The Claiborne Sketch Plan No. 320170030

Completed: 10/28/2016

SECTION 1: RECOMMENDATION AND CONDITIONS

Staff recommends approval of the Claiborne Sketch Plan No. 320170030, for a mixed-use building of up to 76,000 total square feet including up to 73,200 square feet of residential development for up to 58 dwelling units, and up to 2,800 square feet of non-residential uses on 0.30 acres, zoned CR 3.0, C 1.0, R 2.75, H 90T. The following site development elements shown on the Sketch Plan stamped "Received" by the M-NCPPC on September 21, 2016, are binding under Section 59.7.3.3.F:

Figure 2-FAR Averaging/Sending Sites

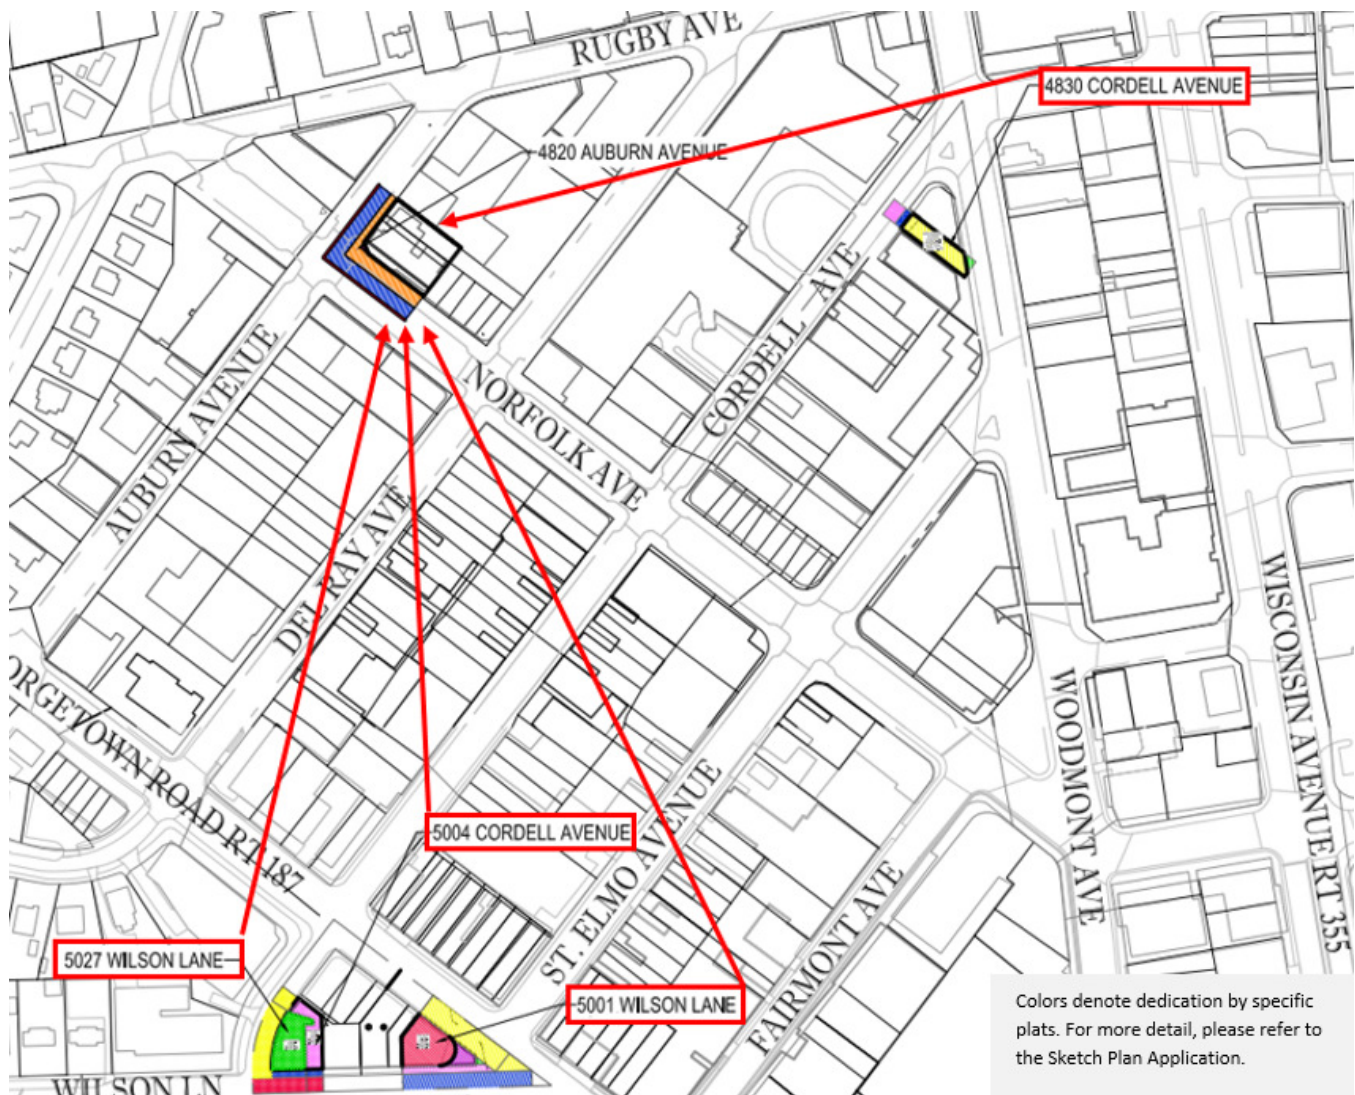
Per Section 4.5.2.B of the Zoning Ordinance – FAR Averaging for Commercial/Residential Zones, and consistent with the recommendations of the *Woodmont Triangle Amendment*, the Applicant proposes to transfer a total of 23,975 square feet of residential density to the Subject Property from Sending Properties via the FAR averaging provisions of the Zoning Ordinance (Attachment A). All Sending Properties will retain sufficient commercial density to cover the existing development, as conditioned above. Furthermore, all properties covered by this Application will conform to the maximum FAR limits allowed under the particular Commercial/ Residential Zone.

Figure 3-Proposed Sketch Plan

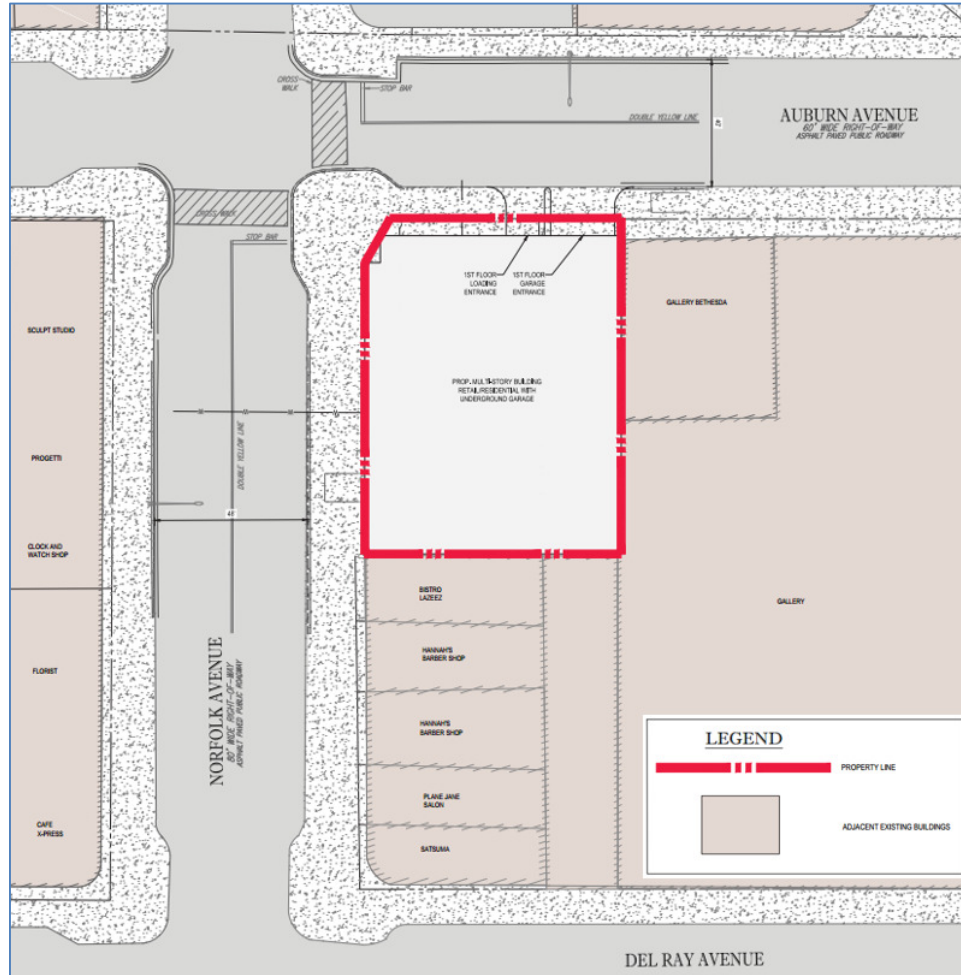
On the Norfolk Avenue façade, the Applicant must step back the building above the fourth floor a minimum of 10 feet over a least 70 percent of the façade.

The Project has been designed to respond to the pedestrian/ transit oriented and urban nature of the Woodmont Triangle area. The base of the building has been set back from both Auburn Avenue and Norfolk Avenue to provide a 15'-wide wide sidewalk and will include a tower step-back above the four-story base to reduce the perceived mass of the upper stories.

Figure 6-Pedestrian and Vehicular Circulation

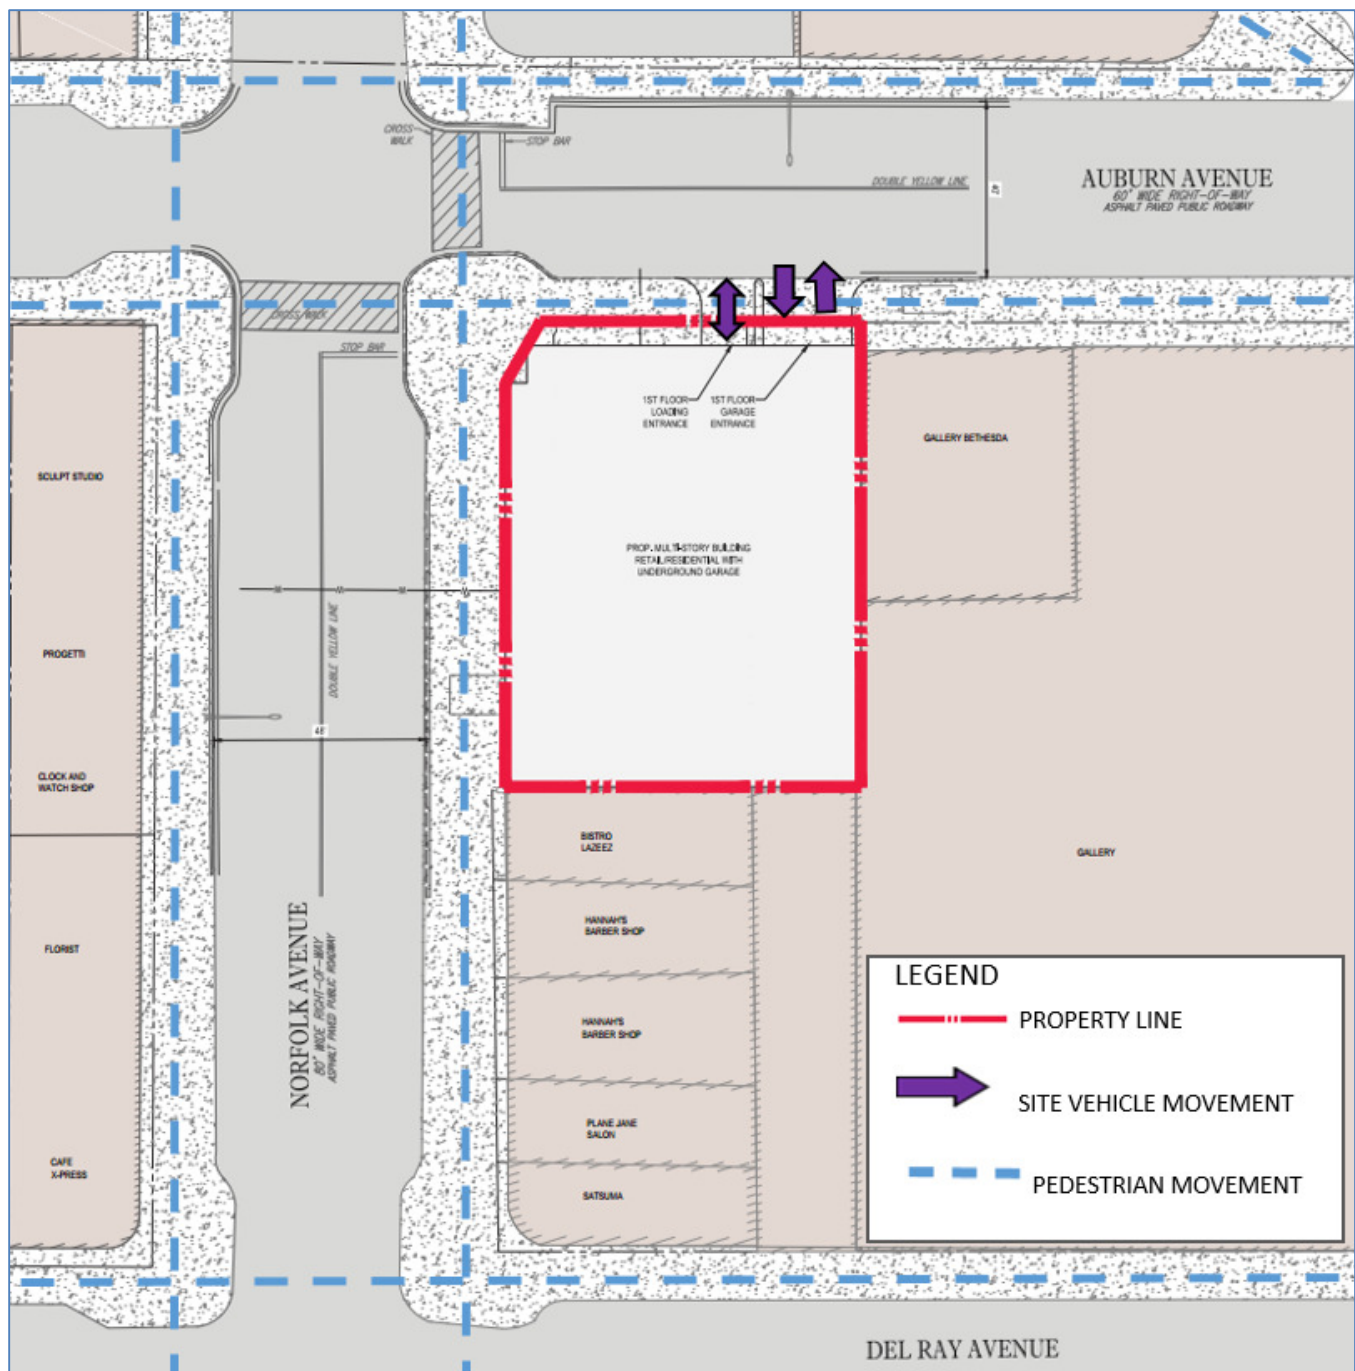
Vehicular access to the Property is proposed directly from Auburn Avenue through a consolidated garage access point and loading bay at the north corner of the site. Resident vehicular parking is proposed to be contained within a structured below-grade garage containing approximately 16 parking spaces. The final number of automobile and bicycle parking spaces will be determined at Site Plan based on the number of residential dwelling units. Pedestrian and bicycle access to the Property will be provided along both Auburn Avenue and Norfolk Avenue (Figure 6).
